RE: Lot 8 Block 4 Unit 18 Volcano Cliffs 6605 Cuervo Pl NW Grading and Drainage Plan Engineers Stamp Date 6/17/15 (D10D003J8)

Lot 8 Block 4 Unit 18 Volcano Cliffs RE: 6605 Cuervo Pl NW Grading and Drainage Plan

Engineers Stamp Date 5/14/15 (D10D003J8)

GRADING AND DRAINAGE PLAN LOT 8, BLOCK 4, UNIT 18, VCS

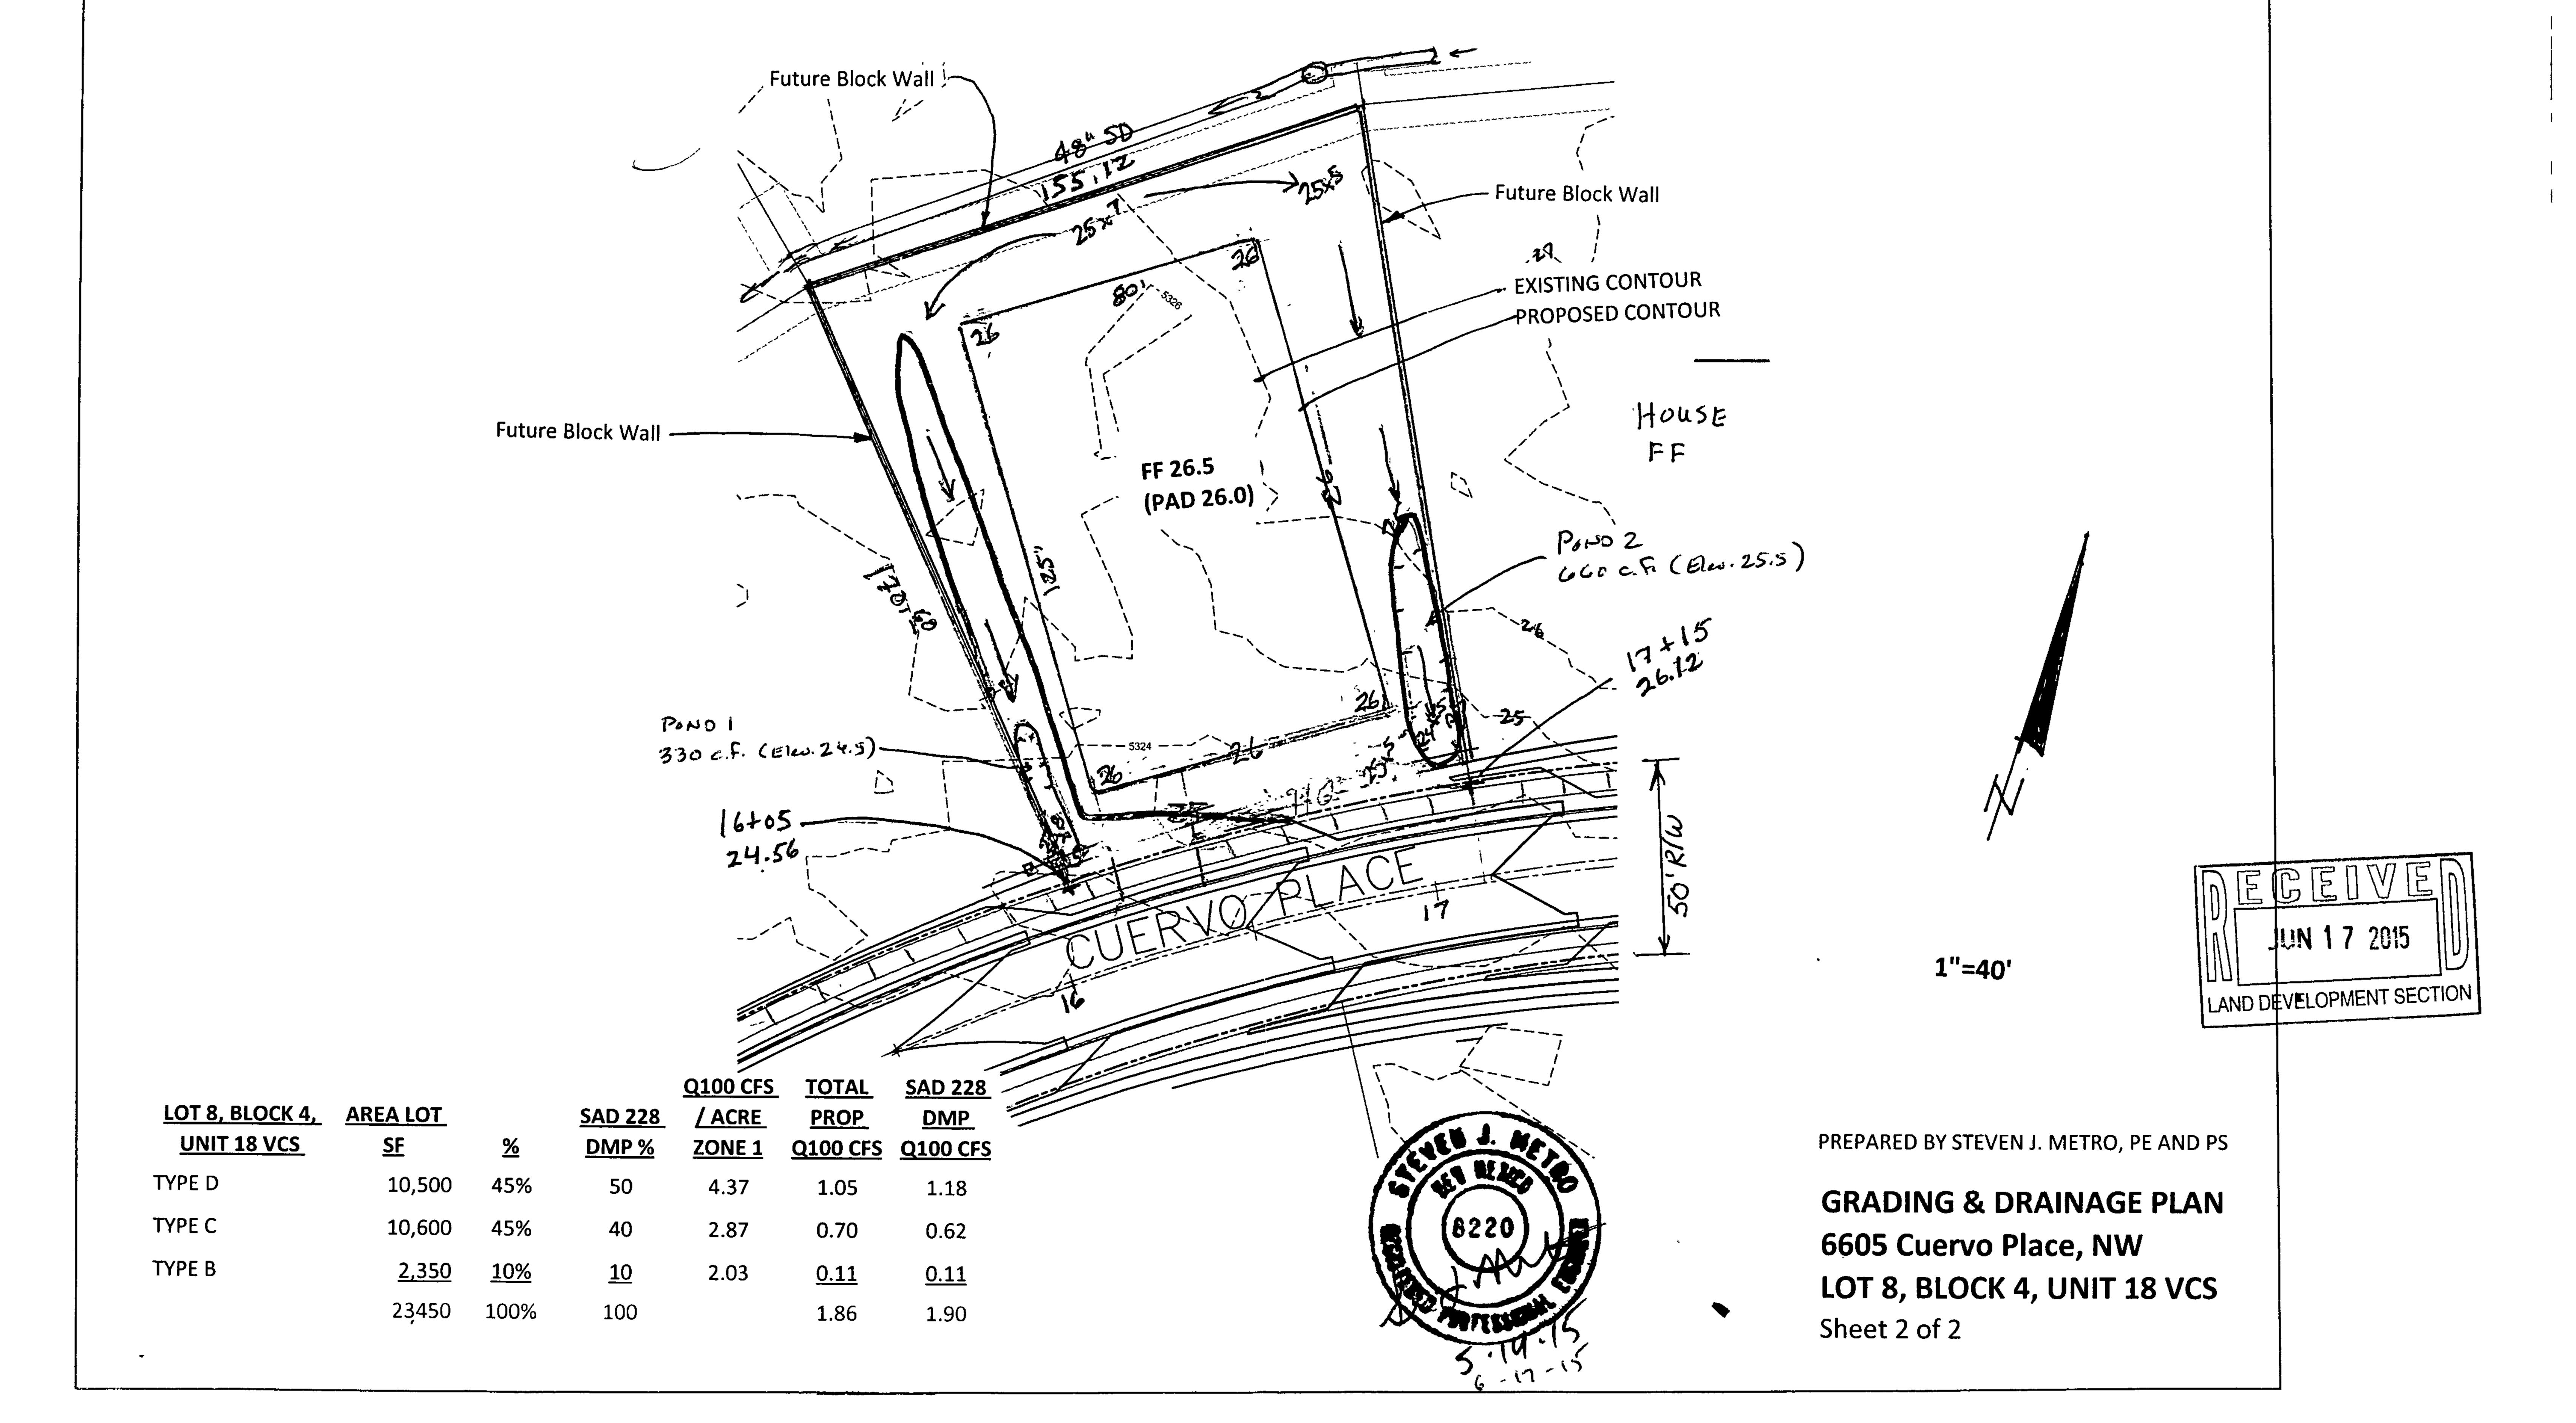
Based upon the information provided in your submittal received 5/15/15, this plan cannot be approved for Grading Permit and Building Permit until the following comments are addressed.

Provide pond bottoms and WSE.
Provide pond volumes.

Development, Inc. 8860 Desert Finch Ln NE Albuquerque, NM 87122 (505) 280-4553 GRADING AND DRAINAGE PLAN LOT 8, BLOCK 4, UNIT 18

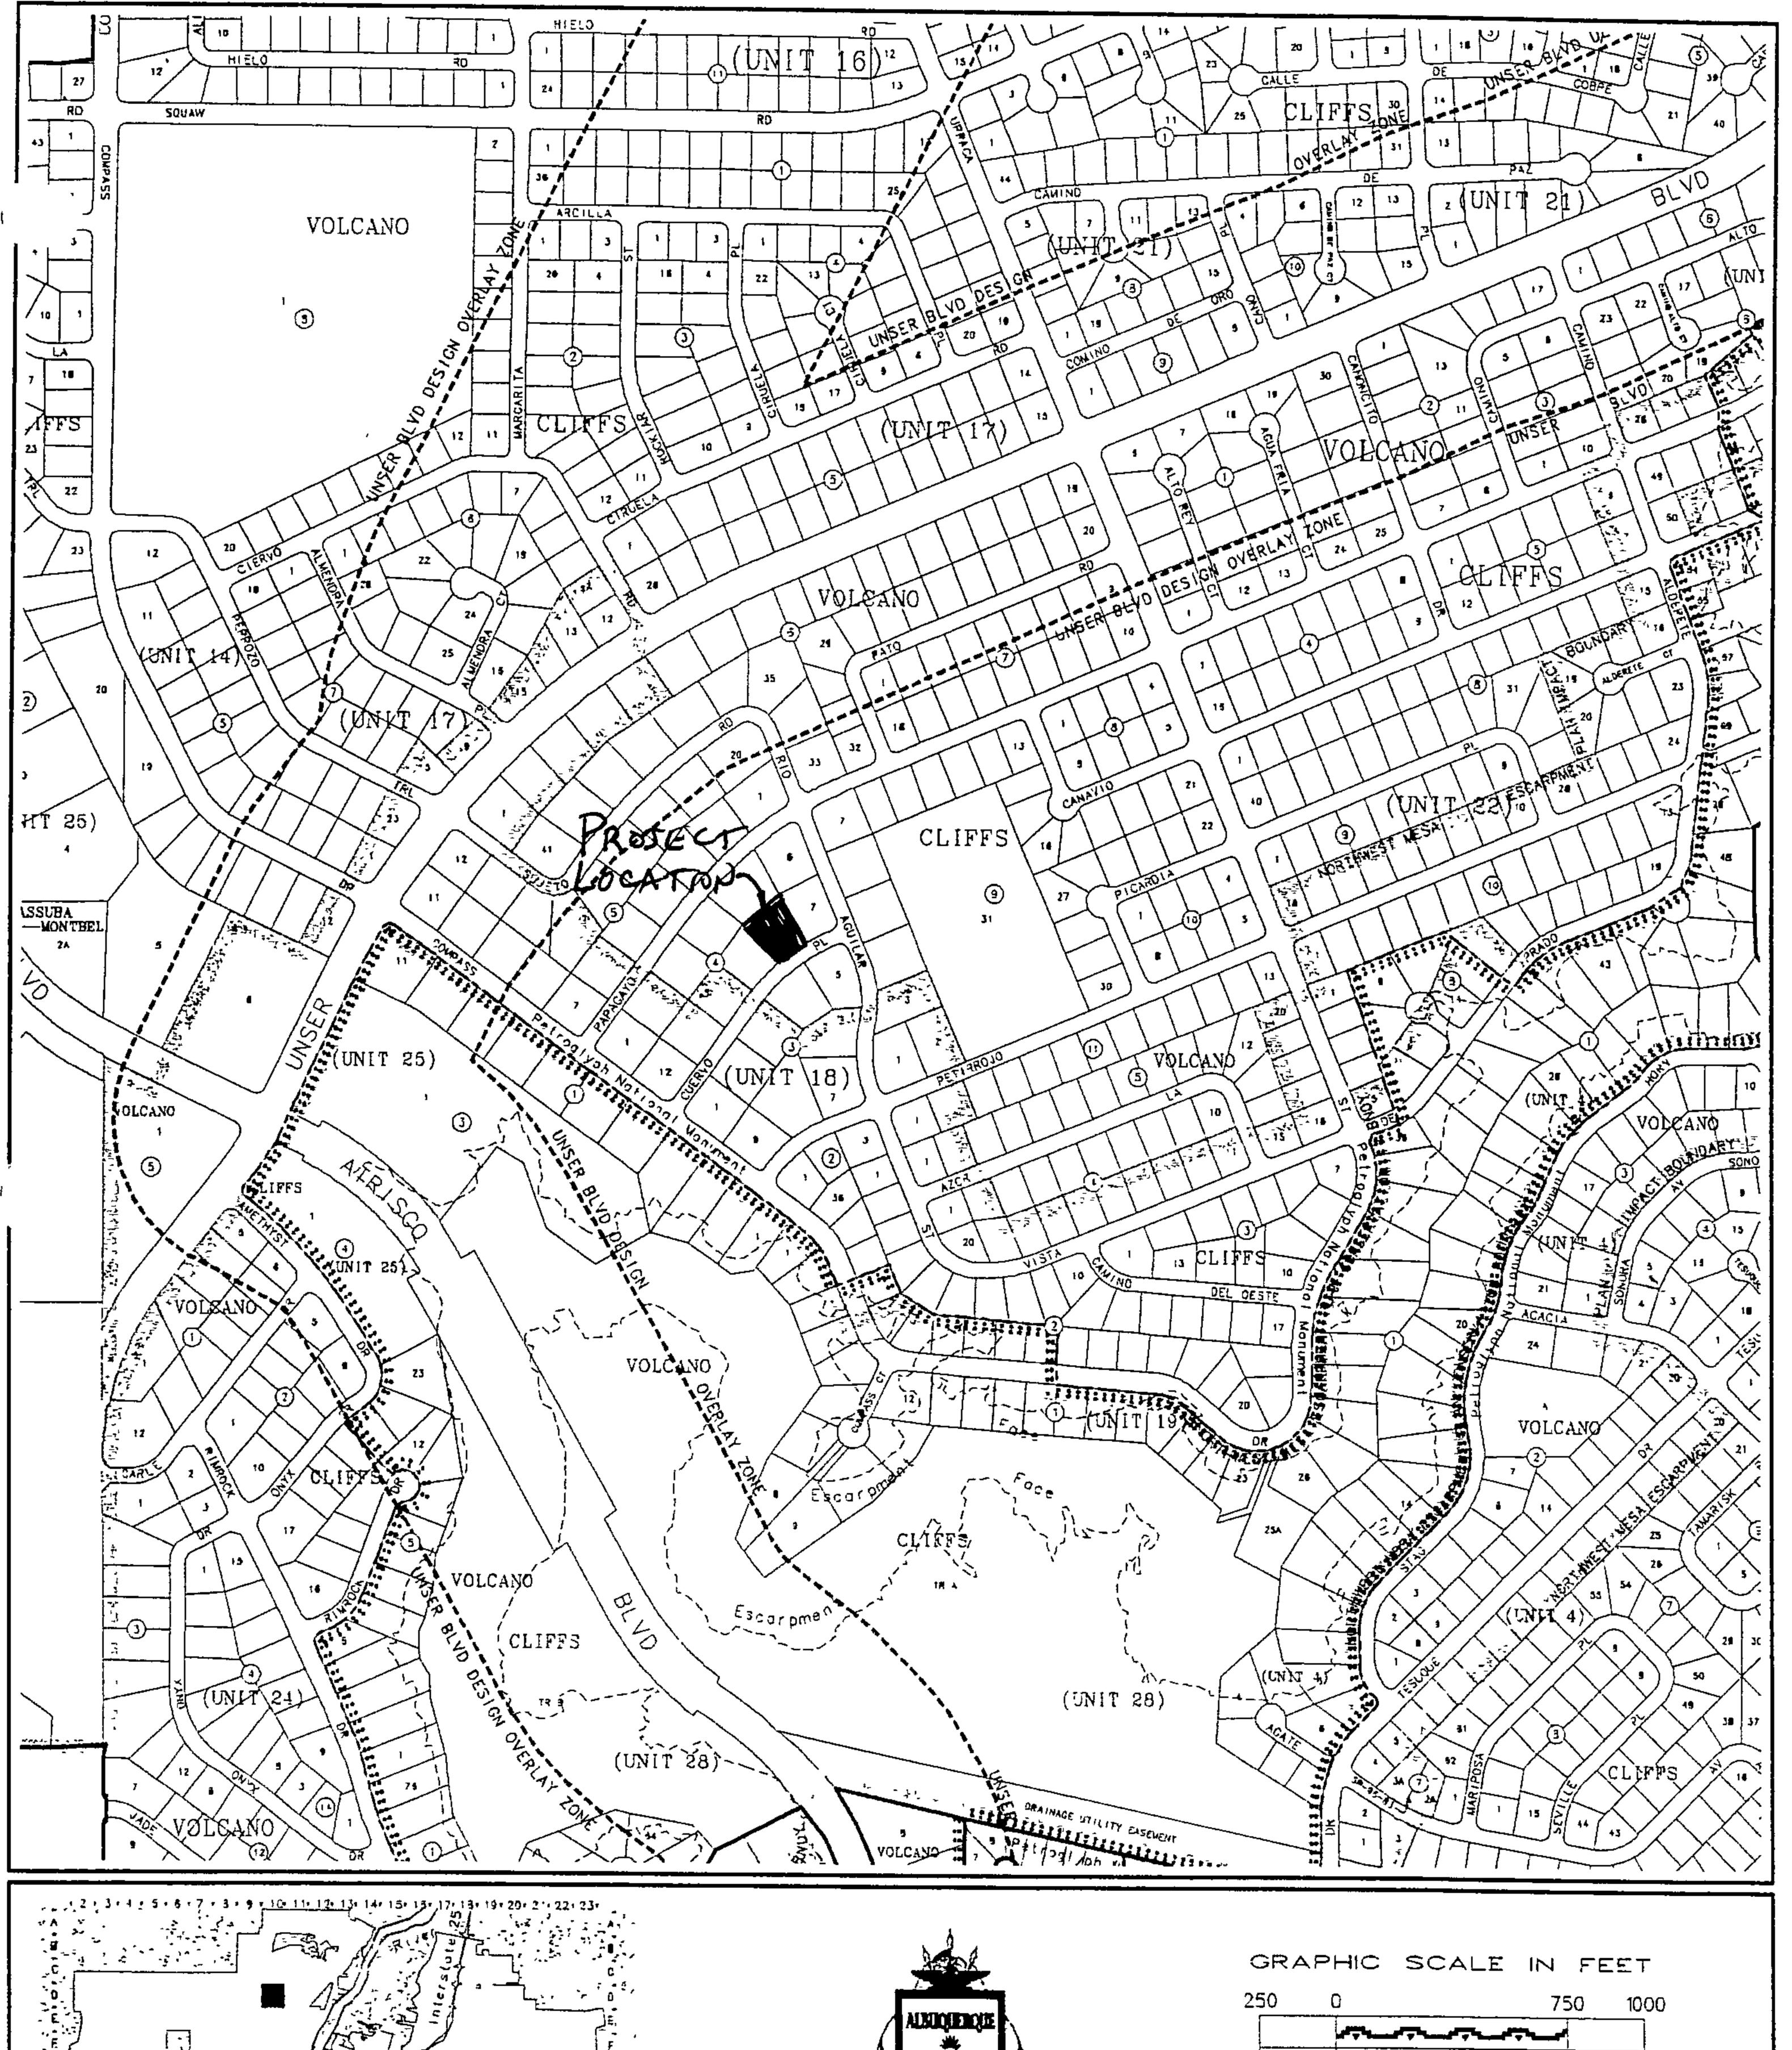
Based upon the information provided in your submittal received 5/15/15, this plan cannot be approved for Grading Permit and Building Permit until the following comments are addressed.

Provide pond bottoms and WSE.

• Provide pond volumes.
